TECHNICAL BULLETIN	
	January 1999 TB 1646
Mfg:	CHRYSLER
Model:	DODGE
Liter:	5.9L
V I N:	6
Year:	98-04

Oil Fill Caution On
1998 Chrysler 5.9L VIN 6 Diesel Engines

Bulletin Diagram: FIGURE 1, CORRECT DIPSTICK IDENTIFICATION - OTHER

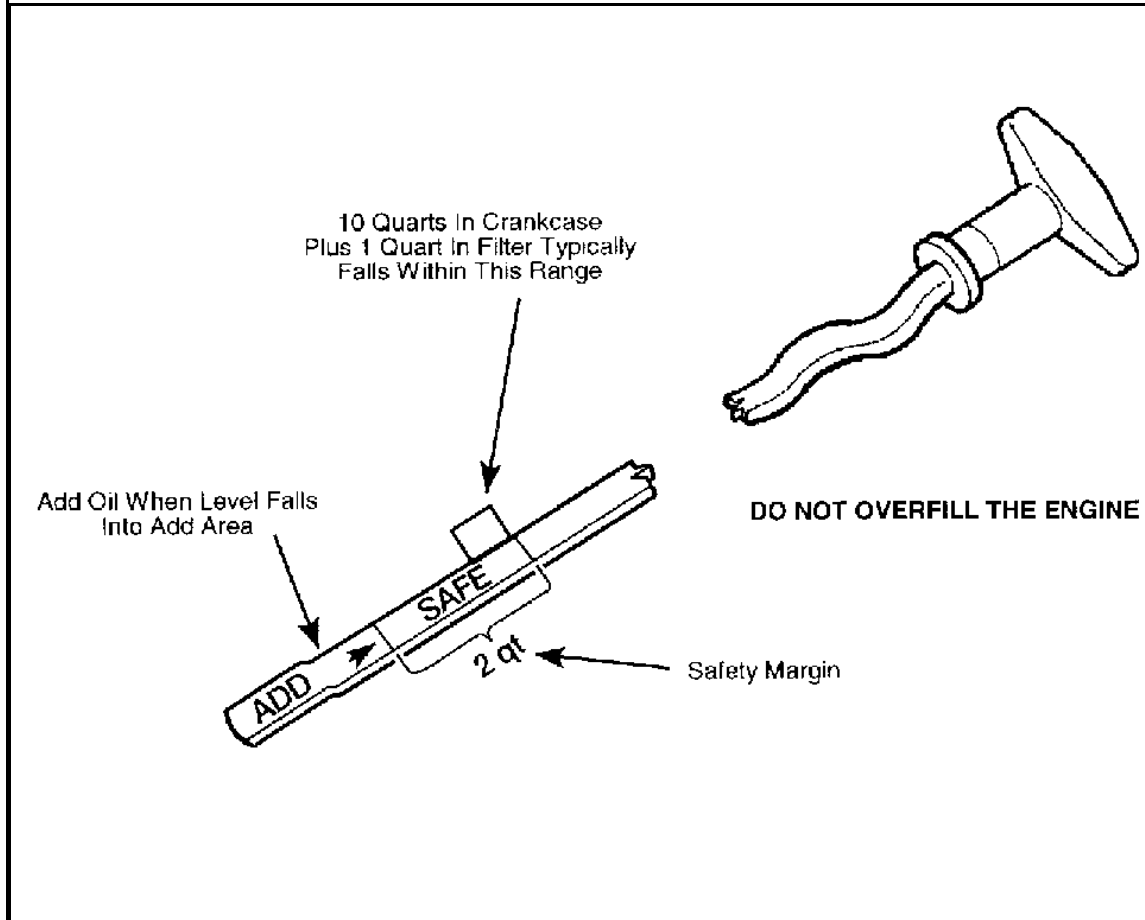
Engines manufactured by Cummins for Chrysler during 1998 were sent out with an incorrect dipstick. This incorrect dipstick will cause an overfill condition of approximately 1.5 quarts when the oil level is at the top end of the safe zone. This overfill condition will not impose any immediate engine concerns, however, several conditions may be created. They include:

The Cummins Part #3944594 is stamped on the incorrect dipstick. It should be removed from the engine and discarded.

A correctly calibrated dipstick is available with Chrysler Part #05014562AA or Cummins Part #3935648. It should resemble the illustration below and it is also stamped with the Cummins part number.

Note: The total capacity of the crankcase is 10 quarts plus 1 quart in the oil filter. The oil level typically reads in the mid to upper section of the safe zone when full. It does not have to be filled to the top edge of the safe zone for the level to be correct.
